# Community Association Response

TO: The City of Calgary, Community Planning, Planning and Development

**RE: LOC2022-0215**

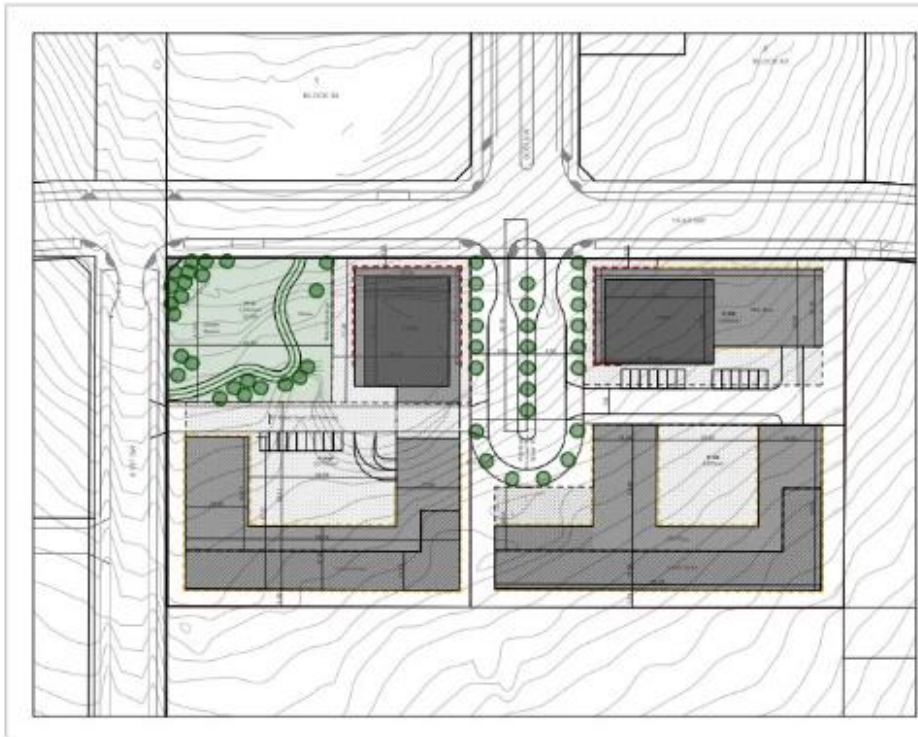
This part of our Community, needs to adhere to the idea of the Liveable Street along 19<sup>th</sup> Ave SW that encourages access by foot and non-motorized vehicles. The original vision in the ASP, was to limit the retail activation along the south side of the Liveable Street - 19<sup>th</sup> ave. The applicant has previously challenged this vision with the Orion development, and is again so doing this with this application.

While only at land use the revised plans and MR treatment direction from the city parks department moves the application further from the NAC concept in our opinion.

The latest plans presented

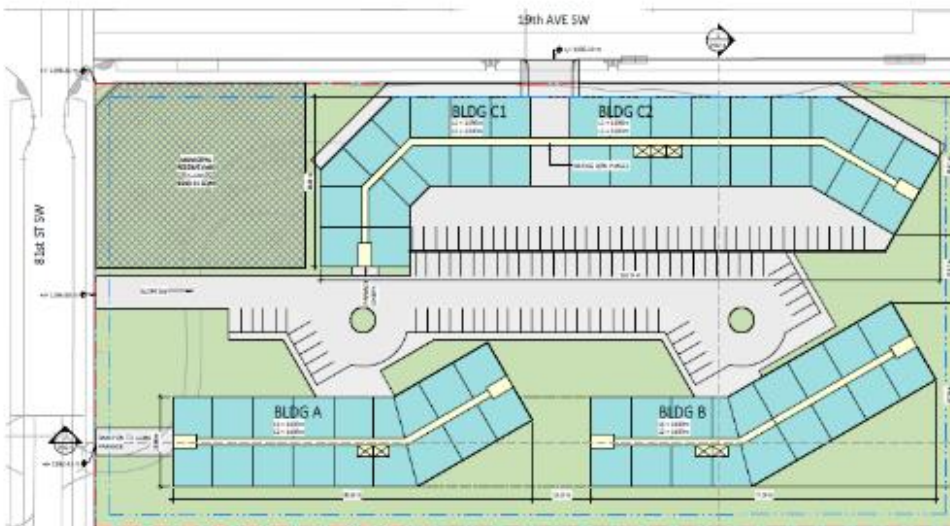
Contains :

- A standard accessway off of 19<sup>th</sup> ave, eliminating the entranceway that would have been the focus of the NAC
- A large surface parking lot
- Two 10 Storey and 2 6 Storey buildings
- Another playground in the MR / Central amenity space

While we understand that a land use application paints with a “broad brush”, the direction of the plans presented would not suggest an intention to create a true NAC space at the DP stage.
